Road Safety Audit Review
Fays Corner
Town of Richmond

July 8, 2004

Road Safety Audit Review Observations

Fays Corner, Richmond

Figure 4. Mike Weisel's Intersection Schematic (not to scale)

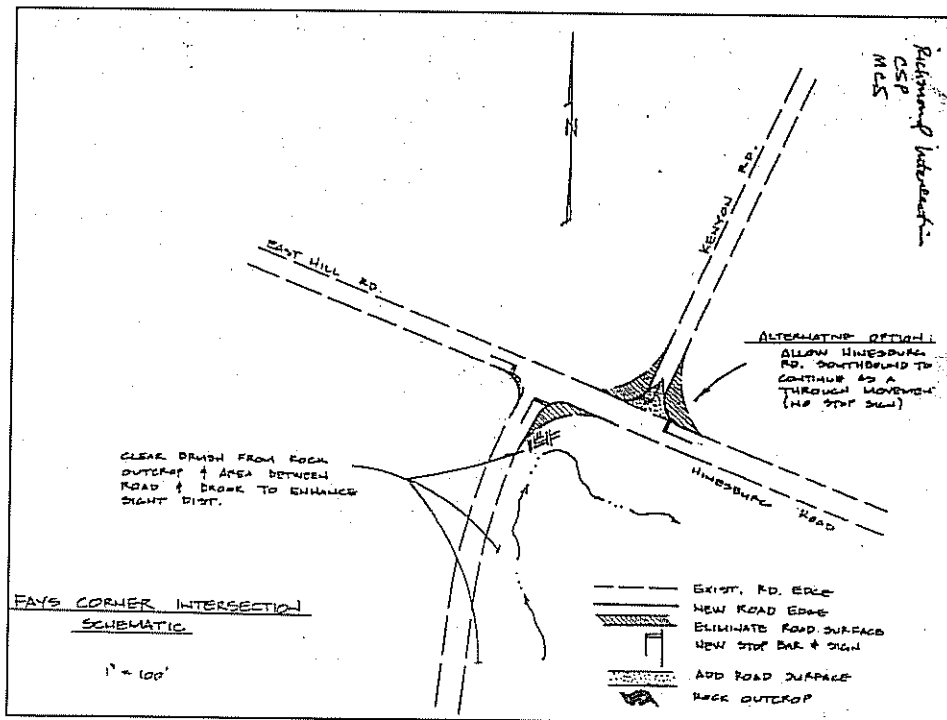
CCMPO contracted with the engineering firm Dufresne-Henry to provide technical assistance to the Town of Richmond with a number of intersections including the one at Fays Corner. In this memo, Dufresne-Henry supports the intersection schematic that was developed by Mike Weisel and which is shown in Figure 4. The following points were made:

- a) Create a four-way stop, or three-way stop condition.
- b) If a 4 way-stop is desired, we recommend regrading the east approach to achieve a suitable grade at the new stop bar (-3%). This would require raising and repaving the road.

- c) Eliminate the large radius on the SE corner, and the "Y" configuration on the north approach.
- d) Leave / allow 40 ft. corner radii (and one foot shoulders where paved) for large trucks and plows.
- e) Place warning signage on the south approach (stop ahead symbol - see W3 -1 A on attached detail E- I 50M) 300 ft. before the intersection.
- f) Place a flashing beacon on this sign post. (see attached Standard Detail E- 1 5 OM).
- g) Place a double arrow warning sign at the intersection opposite the south approach.
- h) Clear the brush and regrade the adjacent area as much as possible on the east side of the south approach.
- i) Place / affix 2 orange flags on each new stop sign. Maintain these for at least a year.
- j) Add road name signage for Hinesburg Rd.

Figure 6 Continued. POOR CORNER SIGHT DISTANCE IS AN ISSUE ON ALL LEGS (top view is of the Hinesburg Rd Approach, from the Town of Hinesburg, bottom view is of Kenyon Rd)

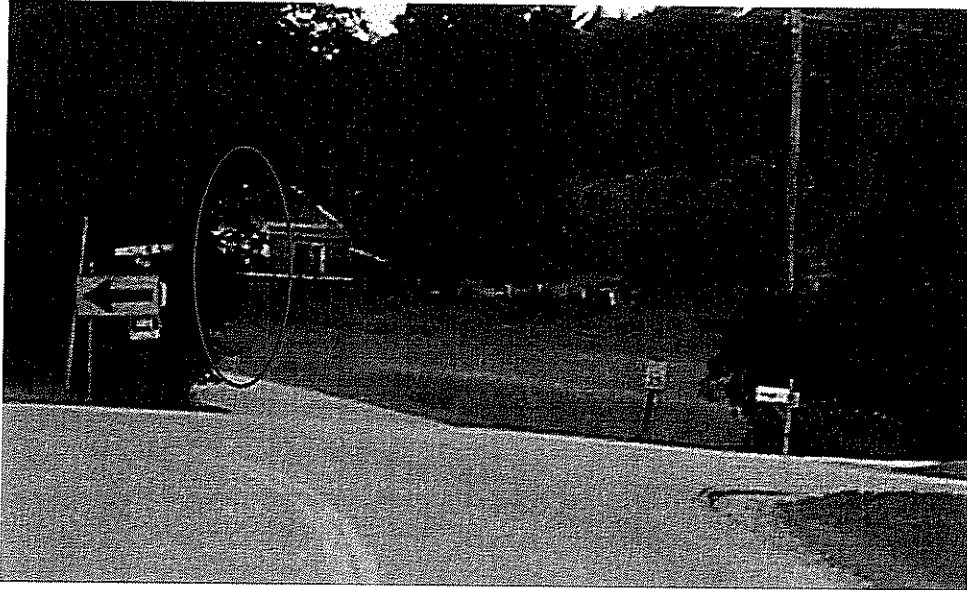
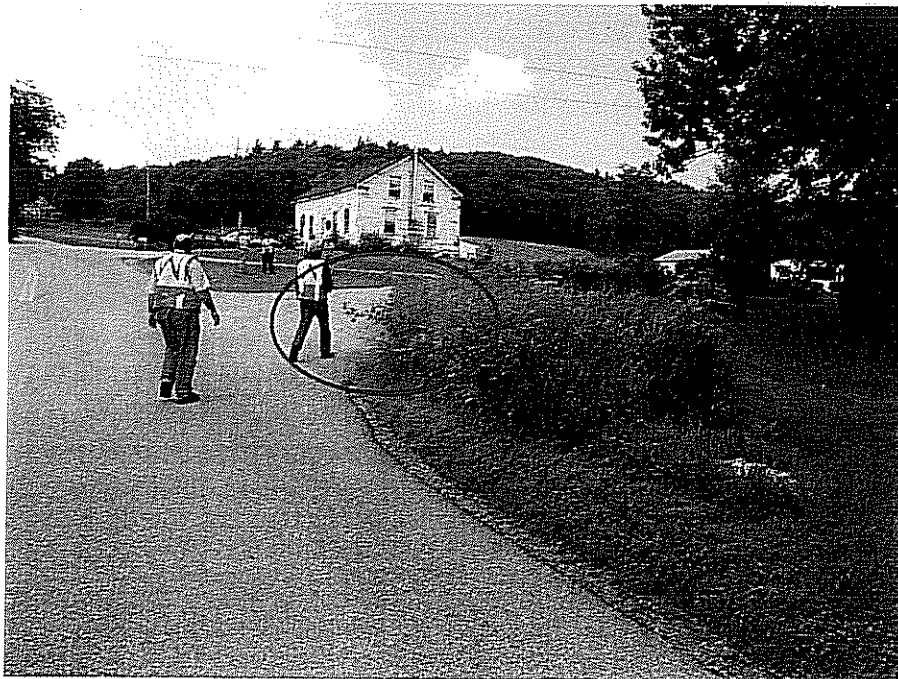
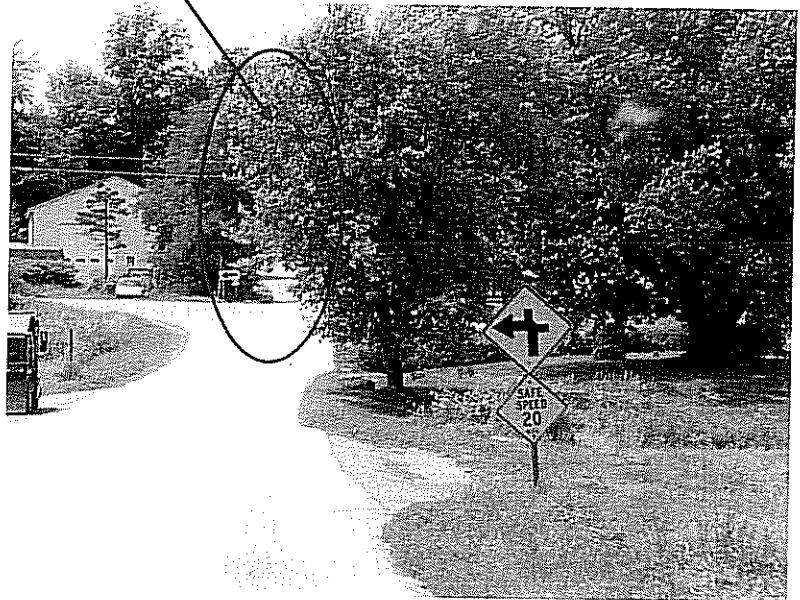
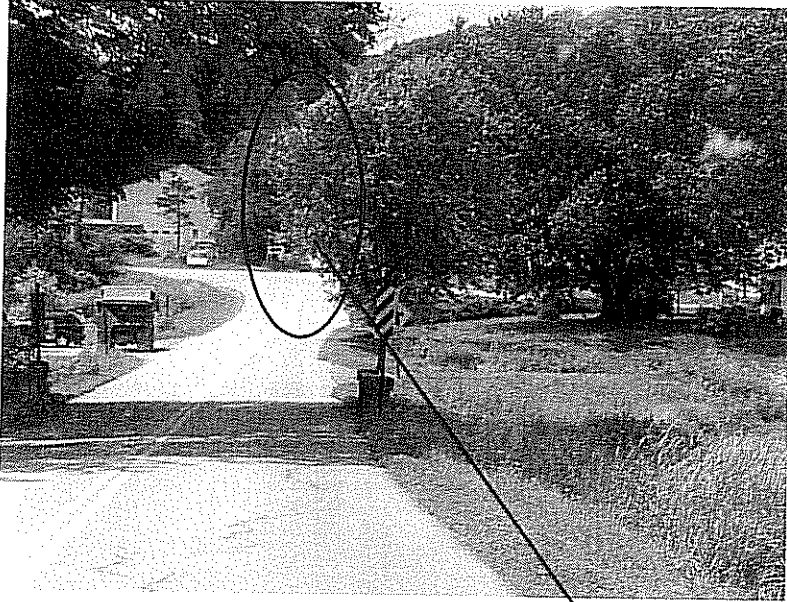
- ✓ Poor corner sight distance is an issue on all legs.
- ✓ The East Hill Stop sign is not visible.
- ✓ The Stop Ahead sign on East Hill is properly located but could be enhanced with word markings.

Observations and Possible Countermeasures	Beg. MM	End MM	Decision Agree/Reject	Planned Completion Date	Reason for Dismissal/Comments
Town's Response (1 of 5)					
<p>1) Poor corner sight distance is an issue on all legs. The Town should consider clearing brush as shown in Figure 6.</p>					
<p>2) The Stop Ahead sign on East Hill is properly located but could be enhanced with word markings. Consider installing "stop ahead" word markings.</p>					
<p>3) The East Hill Stop sign is not visible. The Town should consider clearing brush. Also relocate this sign to a better location (could ask AOT Traf Ops to help with proper location). The Town should also consider upsizing this sign.</p>

Figure 14. SIGN ASSEMBLY NEXT TO EAST HILL RD PROVIDES TOO MUCH INFORMATION

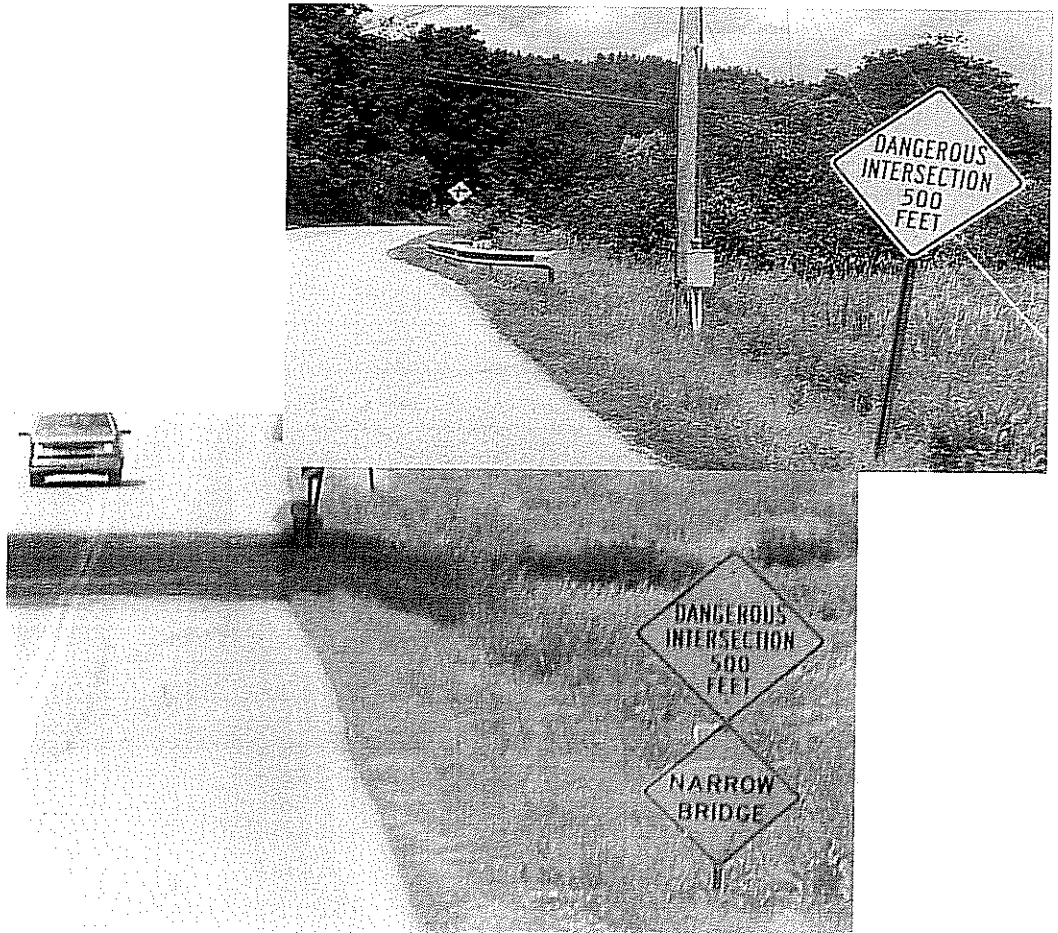
- ✓ Sign assembly next to East Hill Rd provides too much information.
- ✓ There exists a major conflict: traffic going straight on Kenyon Rd from Hinesburg (from the Hinesburg direction) do not have to stop and traffic going straight on East Hill or continuing on Hinesburg from Hinesburg (from the Richmond direction) do not have to stop either.

Observations and Possible Countermeasures	Beg. MM	End MM	Decision Agree/Reject	Planned Completion Date	Reason for Dismissal/Comments
<p>11) Sign assembly next to East Hill Rd provides too much information.</p> <p>The Town should consider separating the signs, keeping the street name signs with the stop sign and leaving the arrow sign by itself.</p>					
<p>12) There exists a major conflict: traffic going straight on Kenyon from Hinesburg (from the Hinesburg direction) do not have to stop and traffic going straight on East Hill or continuing on Hinesburg from Hinesburg (from Richmond direction) do not have to stop either.</p> <p>A stop sign on the south leg should be a last resort. Not everybody needs to stop, only those going straight to Kenyon or turning left on East Hill. Yielding to the right is the action sought. Consider one of the options shown in Appendix A.</p>

Figure 13. TRAFFIC CONFLICTS WERE OBSERVED IN THE FIELD

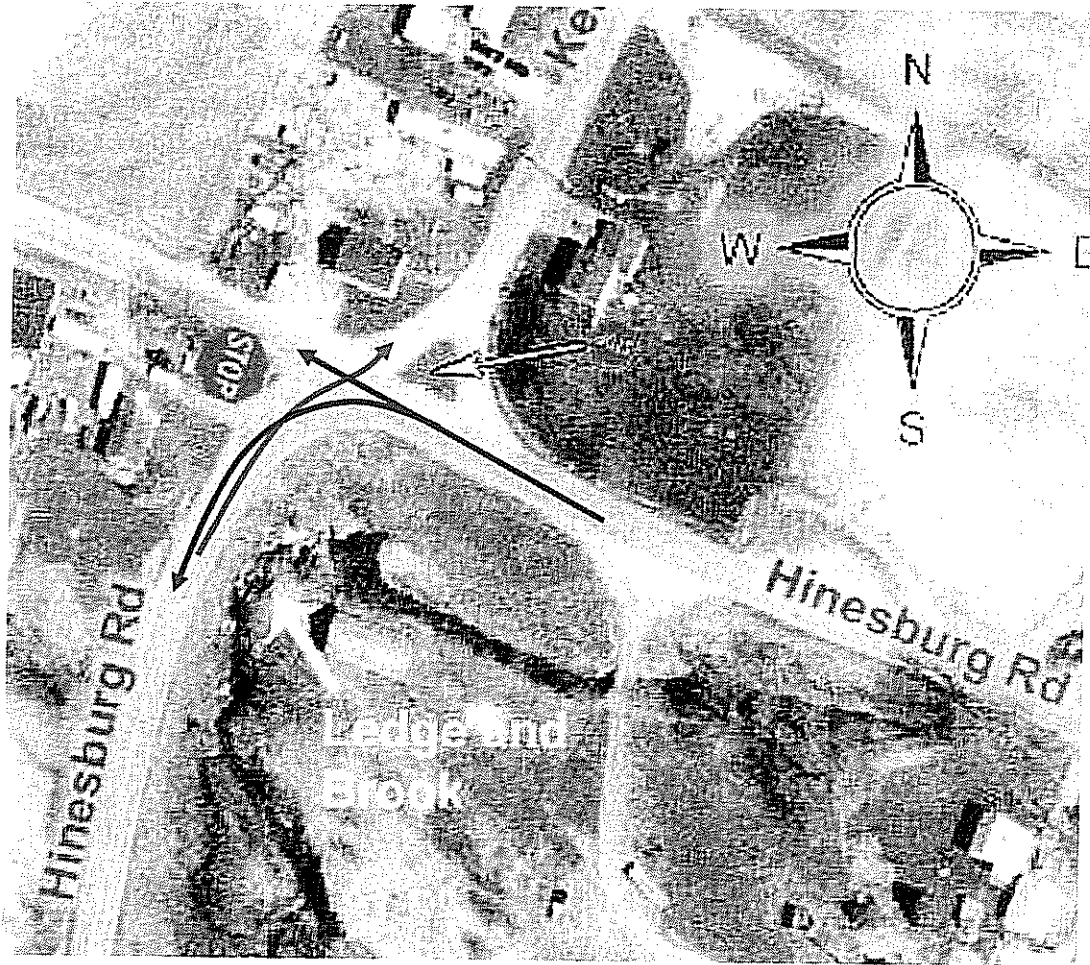
- 6) During the one-hour observation period, four conflicts were observed between somebody wanting to continue on Kenyon Rd and a motorist from the Richmond direction on Hinesburg Rd either going straight on East Hill Rd or turning on Hinesburg (towards Hinesburg). One other conflict was observed with a vehicle turning left on East Hill and a vehicle from Richmond on Hinesburg turning left.

Observations & Possible Countermeasures	Responsible Entities								Strategy
	MPO	Town	AOT Traffic Ops						
There exists a major conflict: traffic going straight on Kenyon from Hinesburg (from the Hinesburg direction) do not have to stop and traffic going straight on East Hill or continuing on Hinesburg from Hinesburg (from Richmond direction) do not have to stop either.		√							The option in Figure 4 could possibly result in more rear-end crashes. A stop sign on the south leg should be a last resort. Not everybody needs to stop, only those going straight to Kenyon or turning left on East Hill. Yielding to the right is the action sought in this case. Consider one of the options shown in Appendix A.

Figure 15. Selected Countermeasures That Could Be Implemented By The Town

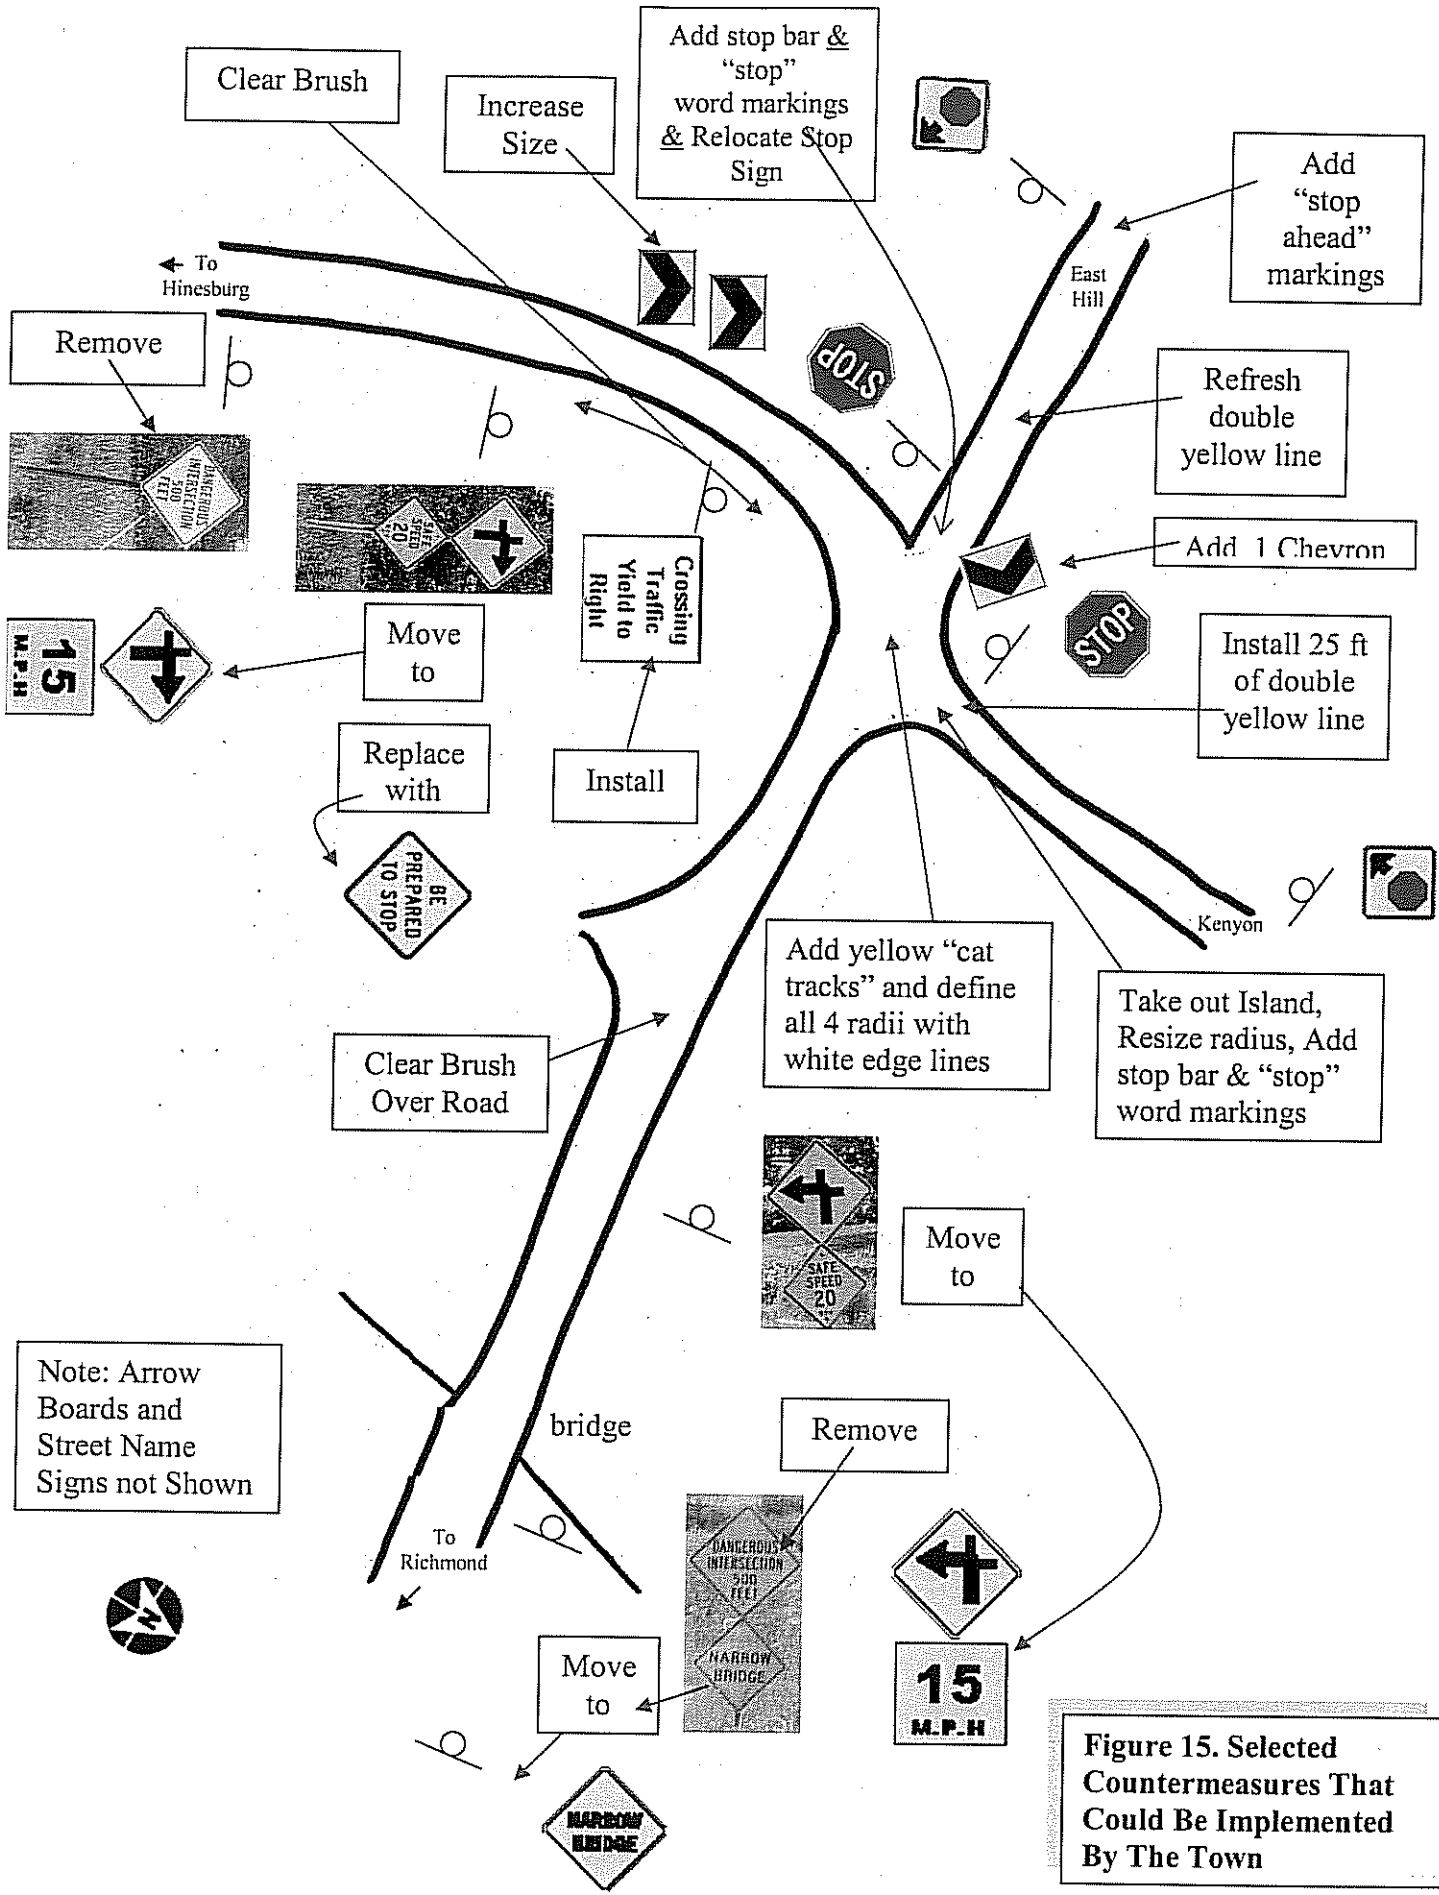
improvements. These tables are found at the end of the report. Selected possible countermeasures for which the Town would be responsible are illustrated in Figure 15.

Observations & Possible Countermeasures	Responsible Entities								Strategy
	MPO	Town	AOT Traffic Ops						
<p>Poor corner sight distance is an issue on all legs.</p> <p>Brush should be removed.</p>		√							The Town should consider clearing brush as shown in Figure 6.
<p>The East Hill Stop sign is not visible.</p> <p>At a minimum brush should be removed.</p>		√	√						The Town should consider clearing limbs of tree, and also relocating this sign to a better location (could ask AOT Traf Ops to help with proper location). The Town should also consider upsizing this sign.
<p>The Stop Ahead sign on East Hill is properly located but could be enhanced with word markings.</p>		√							Consider installing "stop ahead" word markings.
<p>The East Hill approach lacks definition.</p> <p>Additional markings should be considered.</p>		√	√						<p>The Town should consider installing a stop bar and "stop" word markings. The Town could ask AOT Traf Ops to help spot the stop bar.</p> <p>The double yellow line needs to be refreshed.</p>
